SERVICE BULLETIN

APPLICABILITY: 2022-26MY WRX
2024-26MY Impreza & Crosstrek

NUMBER: 10-107-26

SUBJECT: Front Seat Heater Unit / Design Change

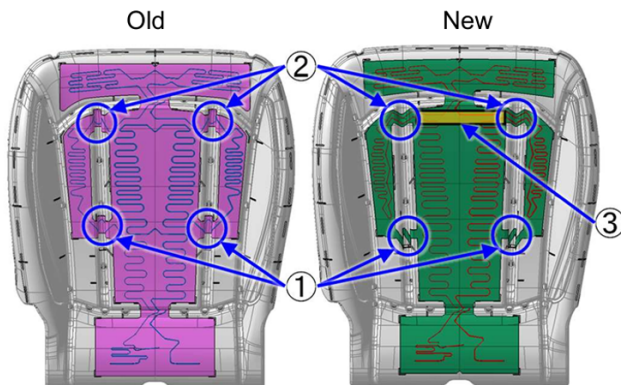
This bulletin announces design changes to the front seat bottom heat unit. The updated seat heater now features a revised wire layout to reduce stress, a modified wire shape at the cushion pad groove, and additional double-sided tape for enhanced wire protection. If a concern is reported that seat heaters are not working and the fault is determined to be the lower seat heater grid, follow the procedure outlined in this bulletin.

- ① Changed the layout to avoid receiving the high stress.
- ② Wiring shape change at the seat cushion pad groove

- ③ Additional double-sided tape
